# UNITED STATES PATENT AND TRADEMARK OFFICE

APPLICATION NO.	FILING DATE	FIRST NAMED INVENTOR	ATTORNEY DOCKET NO.	CONFIRMATION NO.
10/080,270	02/21/2002	Dorian Thurston True	42576/254485	6974

# Office Action Summary

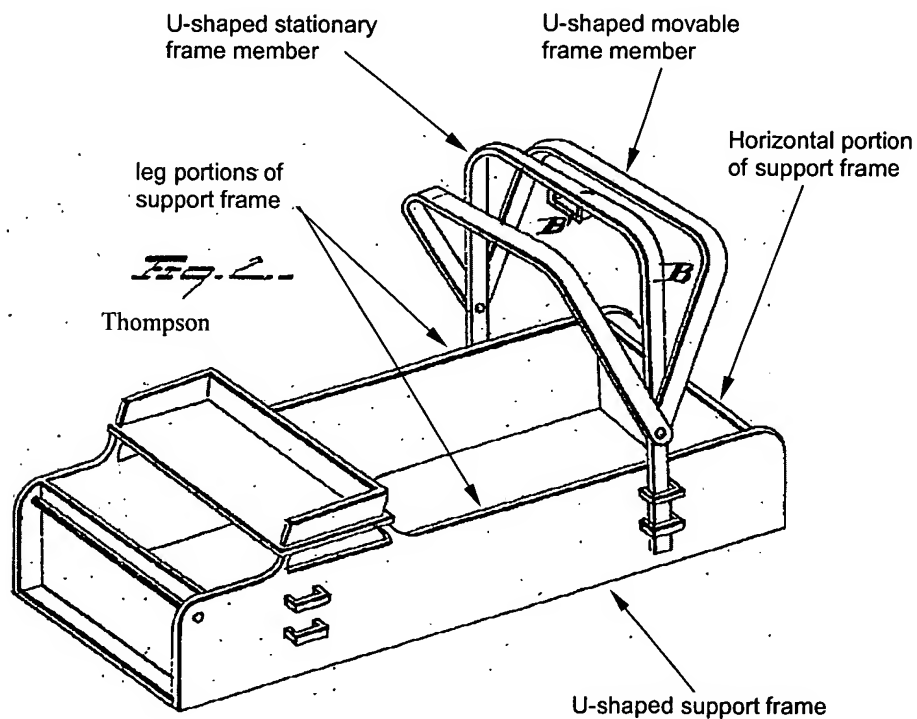
4. Claims 1-4, 6 and 7 are rejected under 35 U.S.C. § 102(b) as being anticipated by Thompson. Thompson discloses an apparatus (Figs. 1-3) for covering a portion of rear compartment of a golf cart, and configured for attachment to a support frame of a golf cart comprising: a stationary member (B) configured for mounting to the support frame member of the golf cart; a movable frame member (Thompson: page 1, col. 2, lines 9-12) configured for mounting to the stationary frame member, and further configured to pivotably rotate over a portion of the rear compartment of the golf cart; and a cover (A) for mounting to the movable frame member rotates over a portion of the rear compartment of the golf cart, the cover covers a portion of the rear compartment of the golf cart; wherein the stationary frame member mounts to a rear portion of the support frame, wherein the stationary frame member connects to a horizontal portion of the support frame; wherein the stationary frame member comprises a U-shaped frame with a horizontal portion and two legs extending relatively perpendicular from the ends of the horizontal portion; wherein the movable frame member comprises a U-shaped frame with a horizontal portion and two legs extending relatively perpendicular from the ends of the horizontal portion; and wherein each leg of the movable frame member mounts to a respective

leg of the stationary frame member (see Figure 2 below). Note: Functional recitation(s) using the words “for” and “configured for” have been given little patentable weight because they fail to add any structural limitations and thereby regarded as intended use language. A recitation of the intended use of the claimed invention must result in a structural difference between the claimed invention and the prior art. If the prior art structure is capable of performing the intended use, then it meets the claim. In re Casey, 370 F.2d 576, 152 USPQ 235 (CCPA 1967) (“The manner or method in which such machine is to be utilized is not germane to the issue of patentability of the machine itself.”); In re Otto, 136 USPQ 458, 459 (CCPA 1963). When interpreting functional language, if the prior art is capable of performing the claimed function—even if not directly disclosed—it anticipates. In re Schreiber, 128 F.3d 1473, 1478, 44 USPQ2d 1429, 1432 (Fed. Cir. 1997). See also MPEP § 2114, 2115.

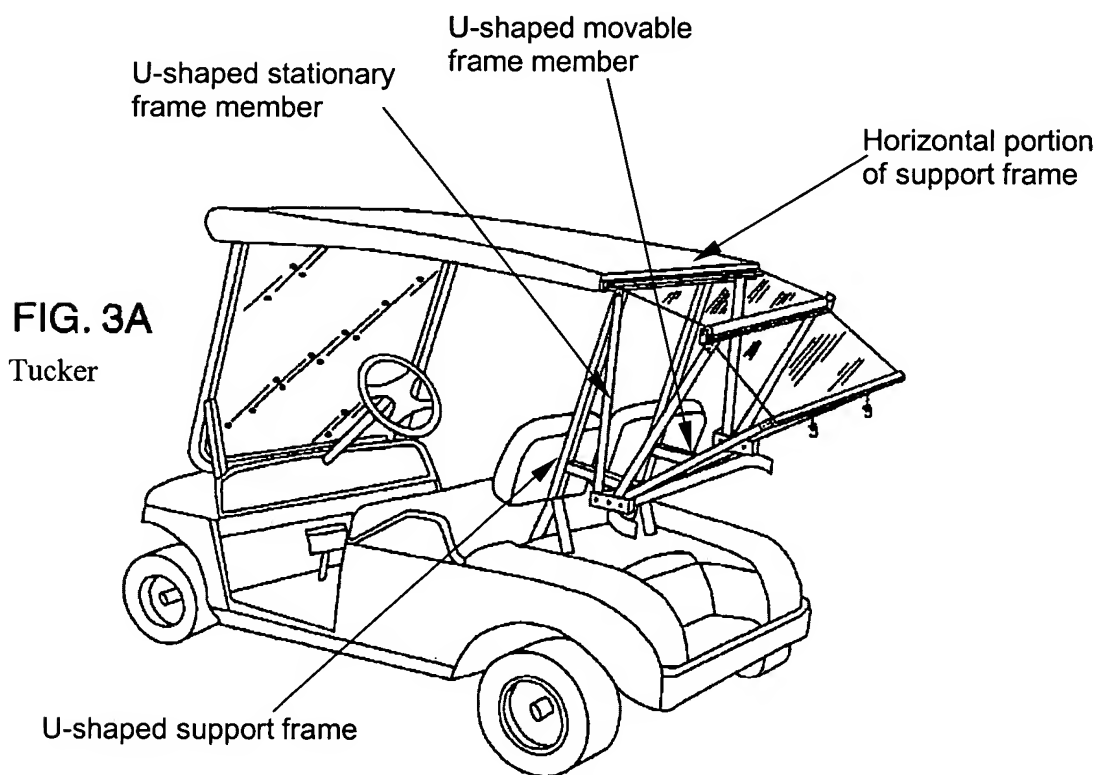
5. Claims 1-7 are rejected under 35 U.S.C. § 102(e) as being anticipated by Tucker. Tucker discloses an apparatus (Figs. 1-3A) for covering a portion of rear compartment of a golf cart, and configured for attachment to a support frame of a golf cart wherein the support frame supports a hard roof top for the golf cart comprising: a stationary member (6, 10, 1) configured for mounting to the support frame member of the golf cart; a movable frame member (9, 19, 3) configured for mounting to the stationary frame member, and further configured to pivotably rotate over a portion of the rear compartment of the golf cart; and a cover (4) for mounting to the movable frame member rotates over a portion of the rear compartment of the golf cart, the cover covers a portion of the rear compartment of the golf cart; wherein the stationary frame member mounts to a rear portion of the support frame, wherein the stationary frame member connects to a horizontal portion of the support frame; wherein the horizontal portion of the stationary frame member mounts to the support frame of the golf cart; wherein the stationary frame member comprises a U-shaped frame with a horizontal portion and two legs extending relatively perpendicular from the ends of the horizontal portion; wherein the movable frame member comprises a U-shaped frame with a horizontal portion and two legs extending relatively perpendicular from the ends of the horizontal portion; and wherein each leg of the movable frame member mounts to a respective leg of the stationary frame member (see Figure below).
